# Access Compliance Report

## Public Rights-of-Way

### (Pedestrian Signals)

Intersection ID: N/A	Main Street:	Cross Street: N/A	Location: N/A
ADA ID: A65FE6BEA6AF	Signal Type: One Push Button-Non APS	Overall Compliance: No	Severity Score: BTN 1: N/A BTN 2: N/A No BTN: N/A
Codes/Mitigation Info/Possible Solution		Field Measurements/Component Compliance

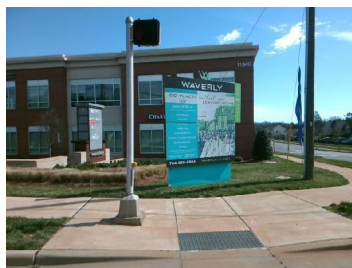
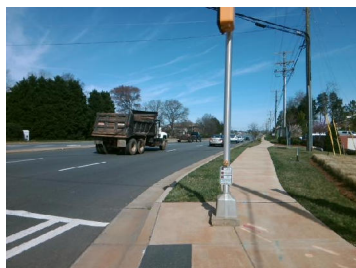
Possible Solutions: Remove and Replace Clear Space.

PROW/ADA: R404.2, R404.3, R404.7.2

N/A	B 1 FWD Approach Width (in)	N/A	N/A	B 2 FWD Approach Width (in)	N/A
N/A	B 1 FWD Approach Obstruction?	Yes	N/A	B 2 FWD Approach Obstruction?	N/A
N/A	B 1 FWD Approach Obstruction Dist (in)	3.0	N/A	B 2 FWD Approach ObstructionDist (in)	N/A
N/A	B 1 PARA Approach?	Yes	N/A	B 2 PARA Approach?	N/A
N/A	B 1 PARA Approach Constrained?	Yes	N/A	B 2 PARA Approach Constrained?	N/A
Yes	B 1 PARA Approach Reach (in)	6.0	N/A	B 2 PARA Approach Reach (in)	N/A
No	B 1 PARA Approach Width (in)	48.0	N/A	B 2 PARA Approach Width (in)	N/A
N/A	B 1 PARA Approach Obstruction?	Yes	N/A	B 2 PARA Approach Obstruction?	N/A
N/A	B 1 PARA Approach Obstruction Dist (in)	4.0	N/A	B 2 PARA Approach ObstructionDist (in)	N/A
No	B 1 Clear Floor Space Slope (%)	5.6	N/A	B 2 Clear Floor Space Slope (%)	N/A
No	B 1 Clear Floor Space XSlope (%)	2.9	N/A	B 2 Clear Floor Space XSlope (%)	N/A
N/A	B 1 PAR Slope (%)	N/A	N/A	B 2 PAR Slope (%)	N/A
Yes	B 1 Height (in)	38.0	N/A	B 2 Height (in)	N/A
